Access Compliance Report

Public Rights-of-Way

Intersection ID: 50248	Main Street: HANBERRY_BV	Cross Street: DERRYRUSH_DR	Location: SE
ADA ID: DCFFD8340E36	Ramp Type: PerpDiag	Initial Pass/Fail: Fail	Overall Compliance: No
Codes/Mitigation Info/Possible Solution		Field Measurements/Component Compliance	
Severity Score: 21.25

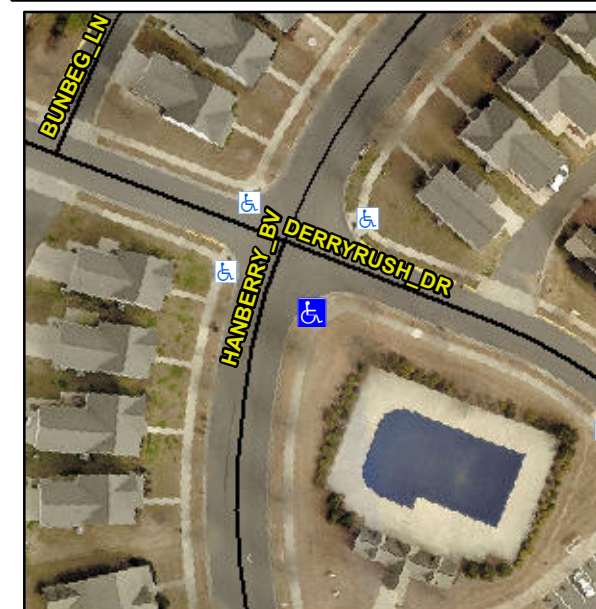
Not Found, R304.5.1, R304.2.2

Compliance	Description	Data	Compliance	Description	Data
N/A	Ramp Length (in)	72.0	No	Ramp Slope (%)	9.1
No	Ramp Width (in)	46.0	Yes	Ramp XSlope (%)	0.6
N/A	Flare Type LT	N/A	N/A	Flare Type RT	N/A
N/A	Flare Slope LT (%)	N/A	N/A	Flare Slope RT (%)	N/A
N/A	Flare Traversable LT?	N/A	N/A	Flare Traversable RT?	N/A
N/A	Landing Length (in)	N/A	N/A	DWS Provided?	N/A
N/A	Landing Width (in)	N/A	N/A	DWS Contrast?	N/A
N/A	Landing Slope (%)	N/A	N/A	DWS Length (in)	N/A
N/A	Landing X Slope (%)	N/A	N/A	DWS Full Width?	N/A
N/A	Landing Curb? (Y/N)	N/A	N/A	DWS Offset (in)	N/A
N/A	Shared Landing?	N/A			
N/A	Gutter Ponding?	N/A	N/A	Gutter Slope (%)	N/A
N/A	Gutter Lip Ht (in)	N/A	N/A	Gutter X Slope (%)	N/A
N/A	Painted X Walk1?	No	N/A	Painted X Walk2?	No
	X Walk 1 Direction	To NE		X Walk 2 Direction	To NW
N/A	X Walk 1 Width (in)	N/A	N/A	X Walk 2 Width (in)	N/A
	X Walk 1 Slope (%)	1.3		X Walk 2 Slope (%)	2.7
	X Walk 1 X Slope (%)	2.5		X Walk 2 X Slope (%)	1.4

Remove & Replace Curb Ramp With Two New Directional Ramps or Equivalent.
